CITY OF VALDEZ

APPLICATION FOR VARIANCE

| APPLICATION NUMBER 19033 | DATE 4/30/19 |

ZONING PLAN REVIEW

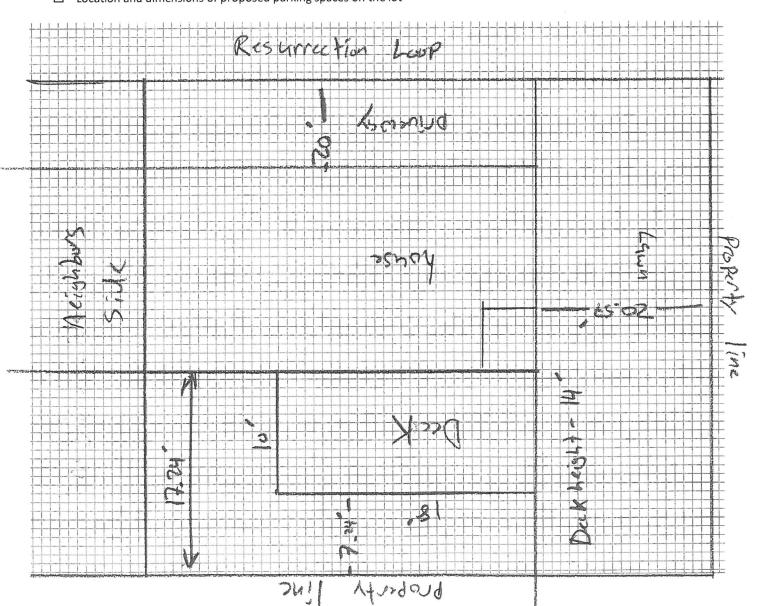
| APPLICATION NUMBER 19033 | DATE 4/30/19 |
|---------------------------------------|--------------------------|
| VARIANCE REQUESTED Variance le ques- | ku for projection of |
| Rear deck &' Into rear set back | |

PERMIT #: 19033 APPROVED: ____ NOT APPROVED X NEED MORE INFO____ DATE REVIEWED: 4 - 24 - 2019 DATE RECEIVED: 4 - 18 - 2019 APPLICANTS NAME: JESSE DEATON LEGAL DESCRIPTION: LOT 20 BLOCK 1 SUBD/SURVEY ST. ELIAS PHASE II STREET ADDRESS: 455 RESURRECTION LOOP ZONING: MULTI-FAMILY RESIDENTIAL DESCRIPTION: CONSTRUCT NEW 10' X 18' REAR DECK USE: MULTI-FAMILY DWELLING PERMITTED: YES X NO NO CONDITIONAL USE PERMIT REQUIRED YES** VARIANCE REQUIRED **SEE COMMENTS BELOW FRONT 20 FT. - SIDE 10 FT. - REAR 15 FT. 7.24** SETBACKS REOUIRED: WELL - SEPTIC - 100' -WATER/SEWER: Calculations: CITY WATER X CITY SEWER X PLOT PLAN X YES NO DRAWINGS NO MAX. BUILDING HEIGHT 35 FEET / ACTUAL HEIGHT 14 FEET ACCESSORY BUILDING _ FEET / ACTUAL HEIGHT _ FEET MAXIMUM LOT COVERAGE 40 % ACTUAL COVERAGE - % TOTAL LOT SIZE (SF) 4009 (Per plat 2007-11) SIGN: NUMBER _- MAXIMUM SIZE _-PARKING SPACES REQUIRED 2 HANDICAPPED ____ [BLDG. SQ. FT. ___/ FLOOD ZONE REVIEW ATTACHED: YES___NO___FLOOD ZONE__ FLOOD PLAIN DEV. PLAN: NO YES (see below) Flood Plain Manager Date SNOW SHEDDING ROOF NO OK **COMMENTS** CONDITIONS / NOTES: **PROPOSED REAR DECK PROJECTS INTO REAR SETBACK. ZONING REVIEW IS DENIED ON THIS BASIS AND THE APPLICANT HAS BEEN RECOMMENDED TO APPLY FOR A VARIANCE IN ACCORDANCE WITH THE PROVISIONS DESCRIBED IN VMC 17.48.040 C. REVIEWED BY: 7 Original to File Copy to Applicant Copy to Zoning Reviewer
